April 16, 2001

Re: NRC INSPECTION REPORT 040-02377/00-02

The response is separated into three sections as follows: 1) response to the five identified deviations in the inspection report (DEV 40-2377/0002-01 through 05), 2) response to the six inspection follow up items identified in the report (IFI 40-2377/0002-06 through 11) and 3) response to specific statements in the text of the inspection report identified by Kaiser.

Kaiser Tulsa Adjacent Land Remediation Project Organization

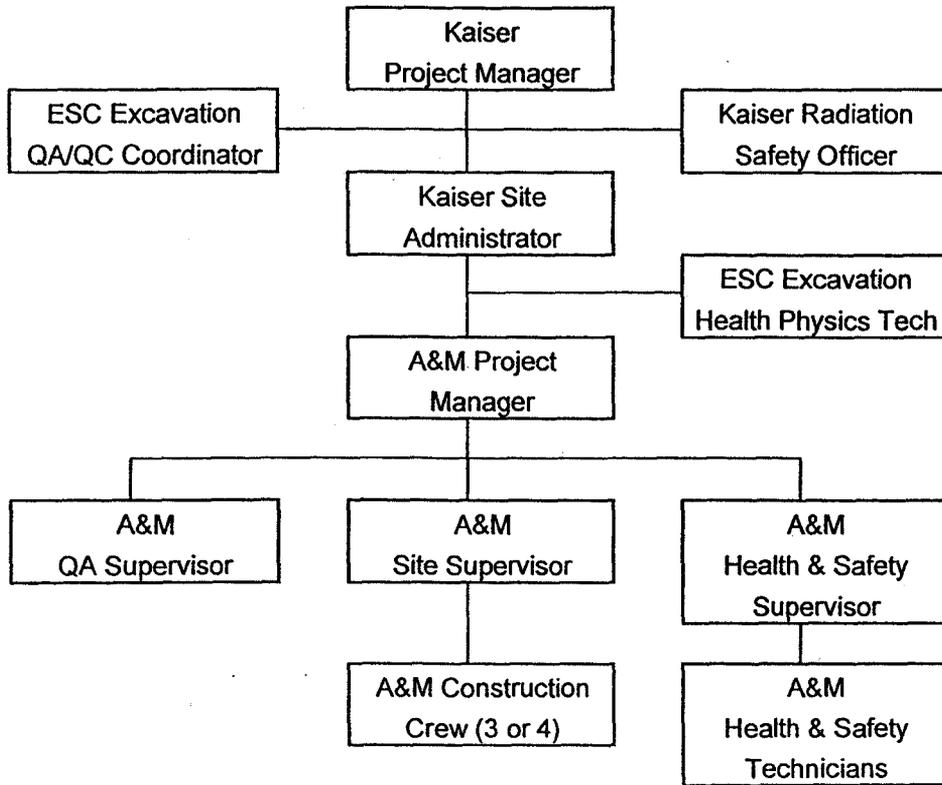
DEV: 40-2377/0002-02 - Failure to have an organization structure that is consistent with Section 2.2.2 of the Remediation Plan.

During the October 2, 2000 NRC site visit, after discussion of the site organization the NRC and Kaiser agreed on the site organization and the organizational chart was revised based on this meeting. Kaiser believes that the revised organizational chart is consistent with the Adjacent Land Remediation Plan. The organizational chart is attached. The positions of ESC Excavation QA/QC Coordinator, Kaiser Site Administrator, Kaiser RSO and ESC Health Physics Technician are included in the chart. The chart is consistent with Section 2.2.2 of the Remediation Plan:

- Section 2.2.2.1 Project Manager, Kaiser corresponds to "Kaiser Project Manager" on the chart.
- Sections 2.2.2.2 Site Manager, Kaiser, 2.2.2.3 Quality Assurance Coordinator, Kaiser and 2.2.2.4 Health and Safety Officer, Kaiser and have been deleted from the Remediation Plan and do not appear on the chart.
- Section 2.2.2.5 Project Manager, contractor corresponds to "A&M Project Manager" on the chart.
- Section 2.2.2.6 Quality Assurance Supervisor, contractor corresponds to "A&M QA Supervisor" on the chart.
- Section 2.2.2.7 Site or Field Supervisor, contractor corresponds to "A&M Site Supervisor" on the chart.
- Section 2.2.2.8 Health and Safety Supervisor, contractor corresponds to "A&M Health and Safety Supervisor" on the chart.
